Re: Approved North Sediment Pond Cleaning Procedure, PacifiCorp,
Cottonwood/Wilberg Mine, ACT/015/019-94C, Folder 32, Emery
County, Utah

**RE: COPIES OF APPROVED NORTH SEDIMENT POND CLEANING PROCEDURE,
PACIFICORP, COTTONWOOD MINE, ACT/015/019, FOLDER #3, EMERY
COUNTY, UTAH**

COTTONWOOD MINE NORTH POND

CLEANING PROCEDURE

REVISED 4/12/94

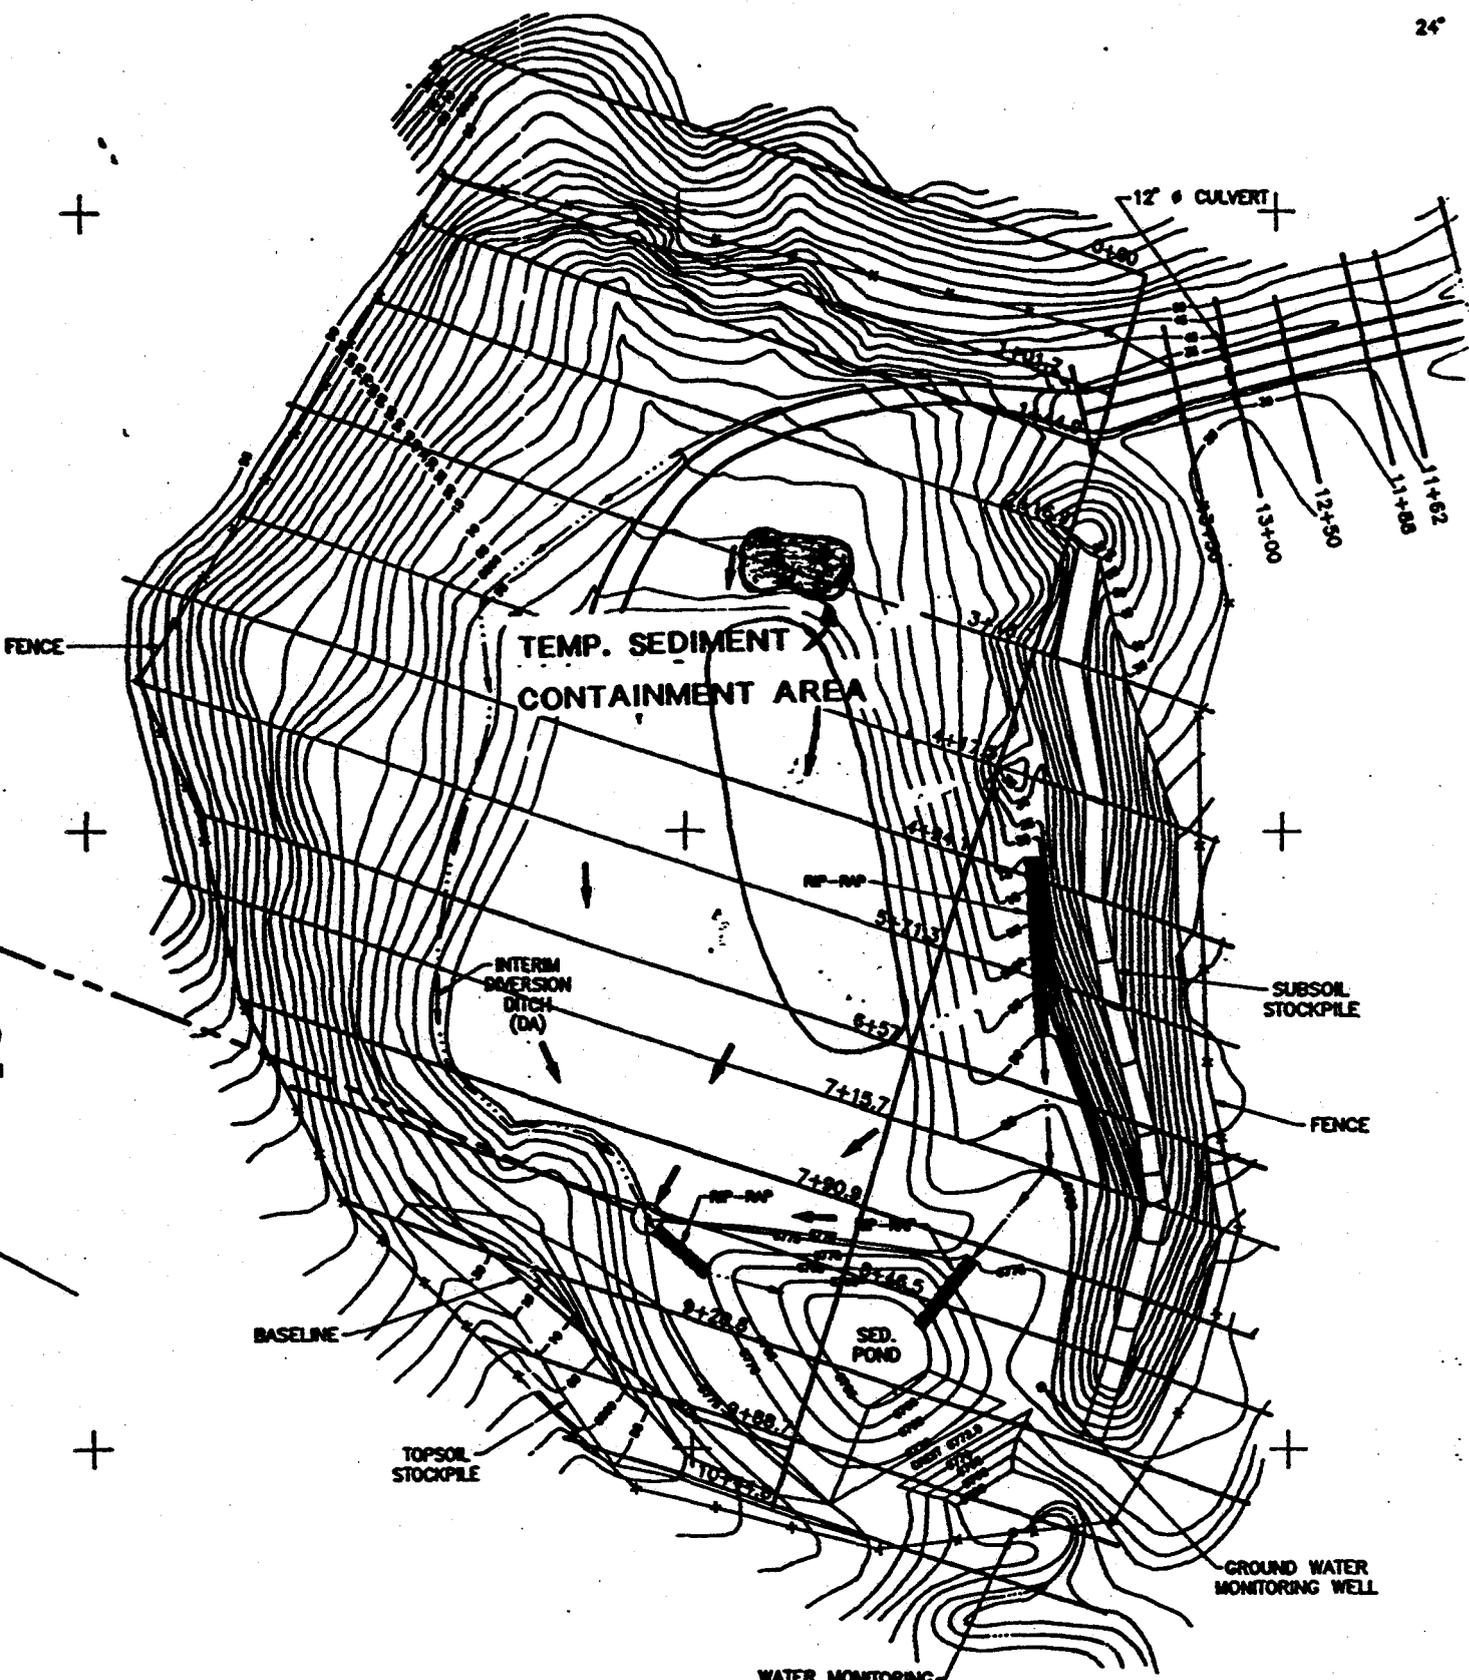
5. A containment area will be made in the Waste Rock Facility for the sediment and remaining water. A site located at the north end of the Waste Rock Facility has been selected (see attached drawing). By the use of this site, the sediment will be contained in a convenient location and water leaching through the compacted refuse would be retarded.

6. Sediment will be removed and mixed with other mine refuse after drying has taken place.
7. Thicker sediment will be placed on the waste rock just south of the temporary sediment containment area (see revised drawing, 4/12/94).
